Development Review Comments

PAM2024-00152

622 Hungerford Drive – Washington Square

WASHINGTON SQUARE
PRE-APPLICATION SITE PLAN
CITY OF ROCKVILLE, MARYLAND

PROJECT NUMBER	0696R
DATE	2023.09.29
SCALE	NTS
DRAWING TITLE	Illustrative Architecture

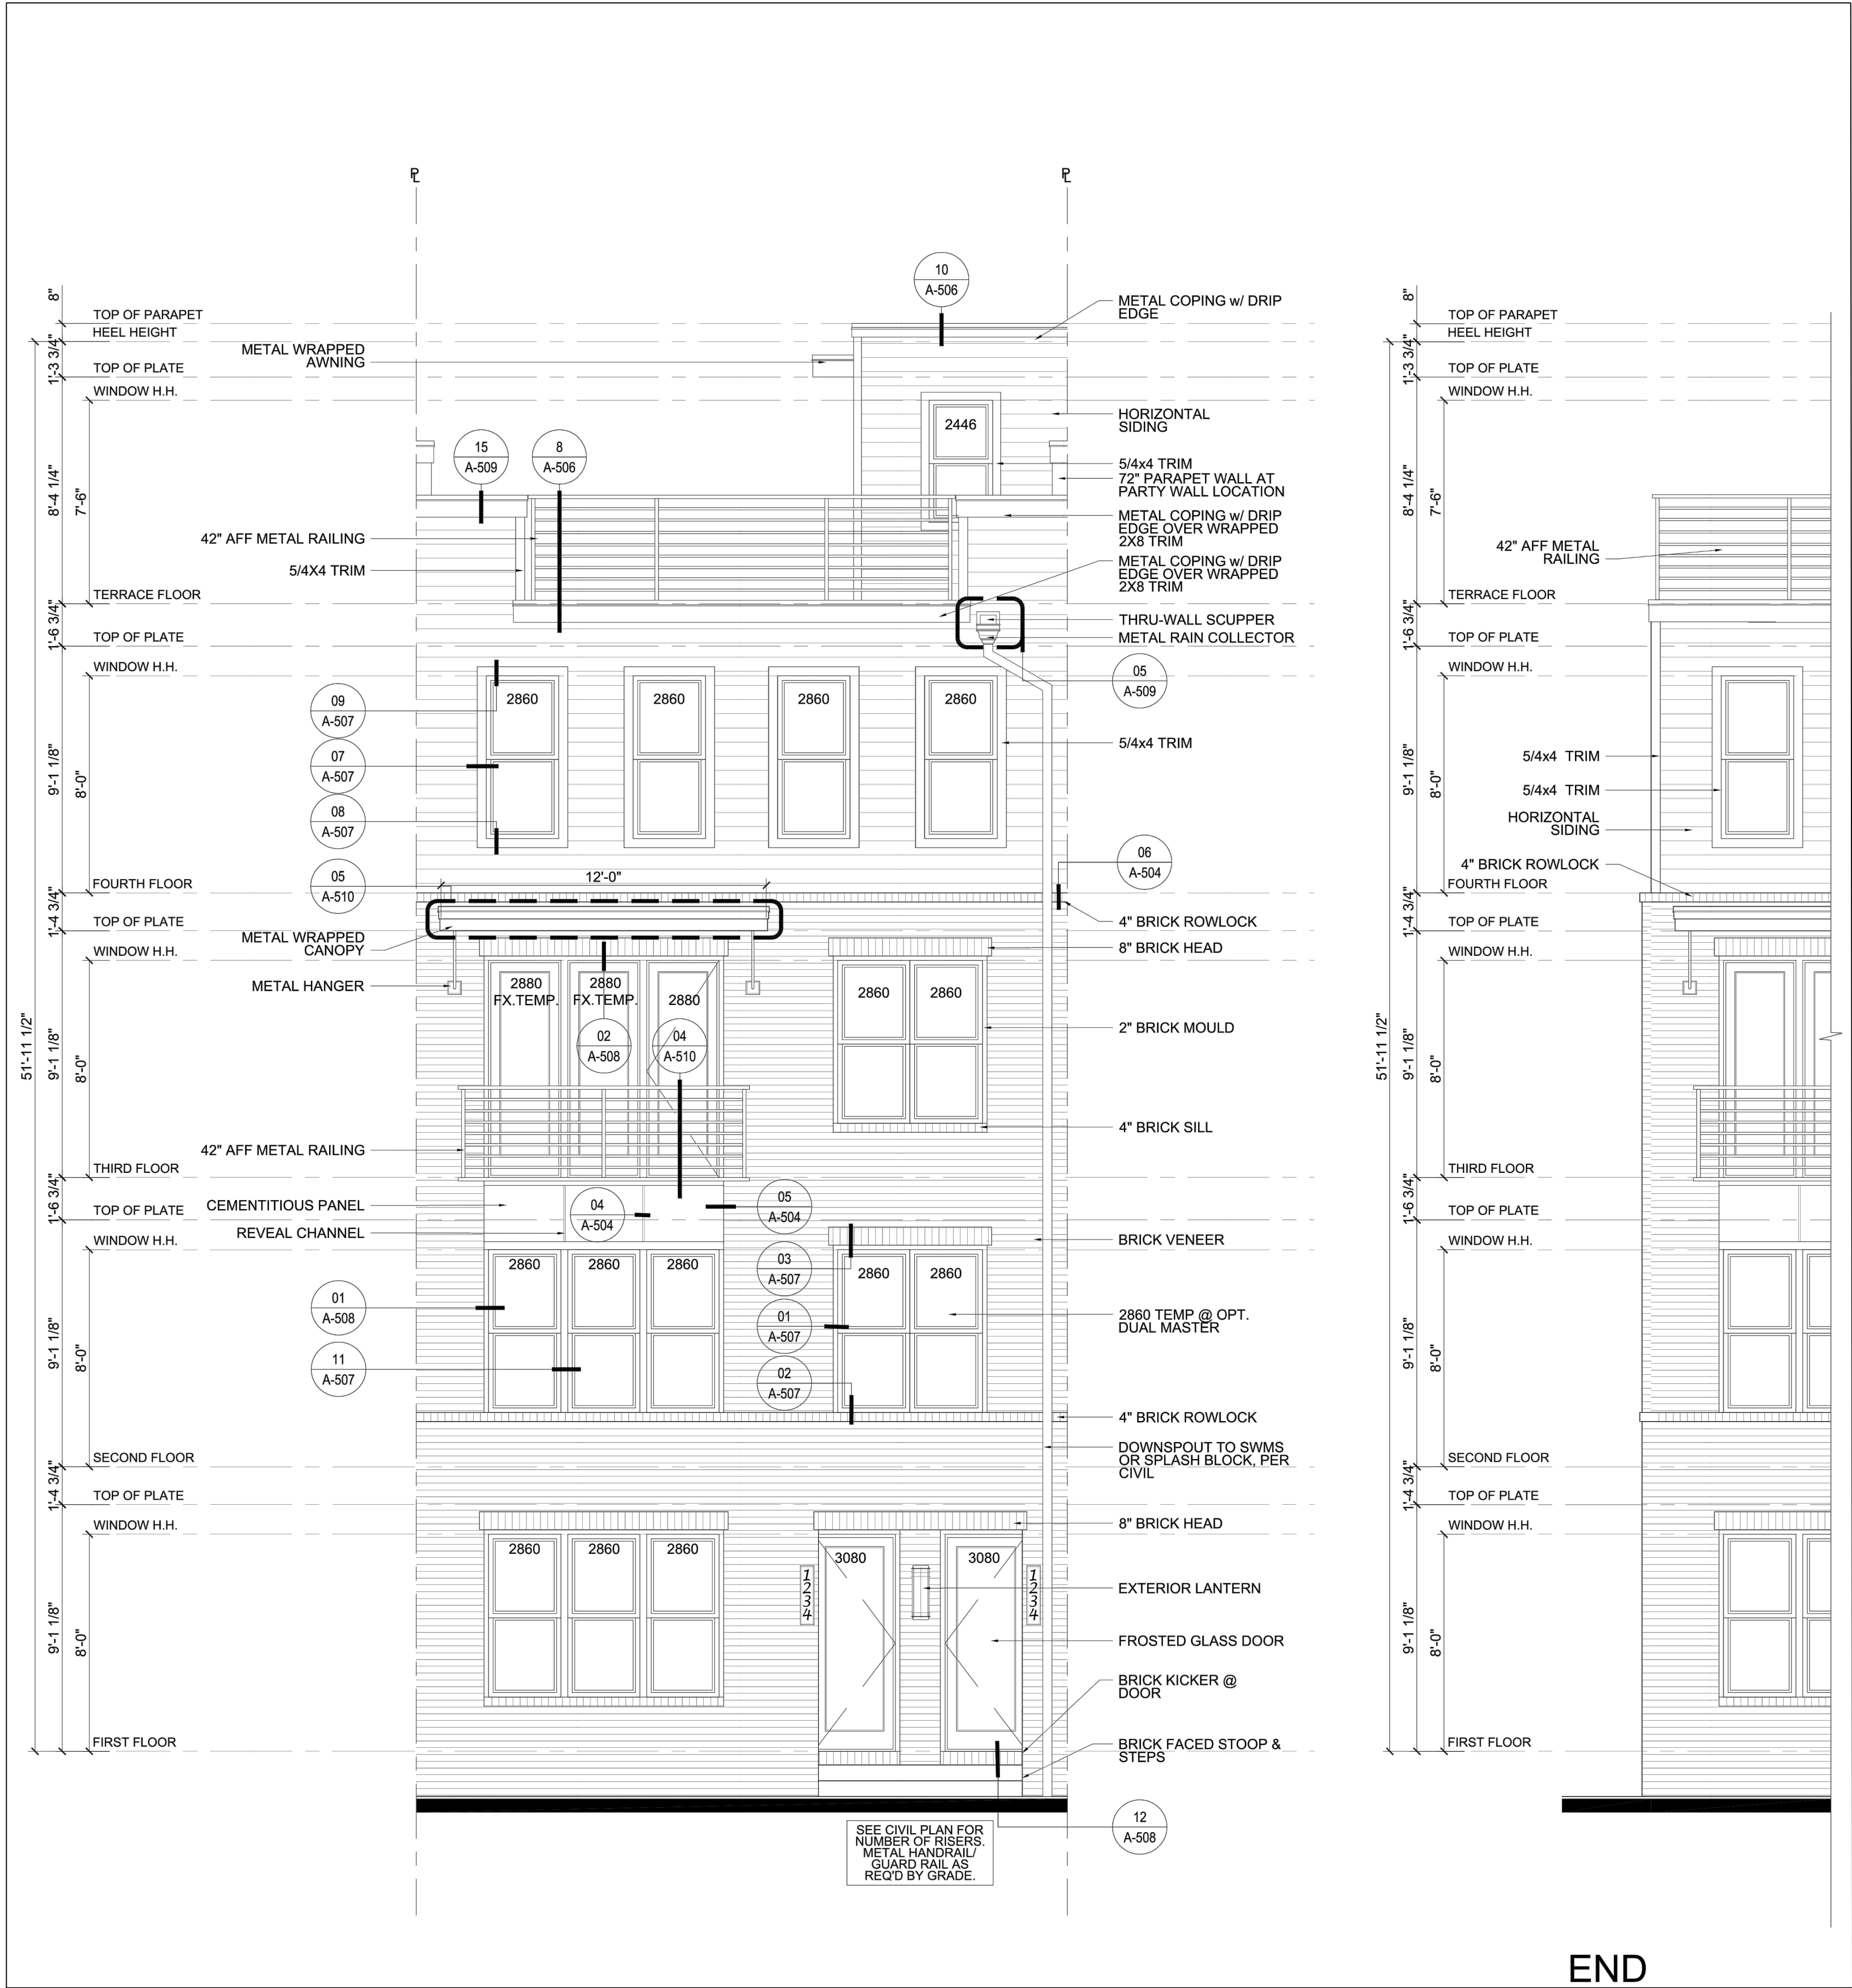
Notes are for informational purposes. Compliance with Sec. 25.13.05, 25.13.06, and 25.13.07 will be reviewed at the time of site plan review.

Note: Per Sec. 25.13.03.b.2, roof design should provide variations in rooflines where appropriate and add interest to, and reduce the massive scale of, large buildings. Roof features should complement the architectural and visual character of adjoining neighborhoods. Roofs should include two (2) or more roof planes. Parapet walls should be architecturally treated to avoid a plain, monotonous look. For energy-saving purposes, roof design should also include a light color surface or be planted with vegetation.
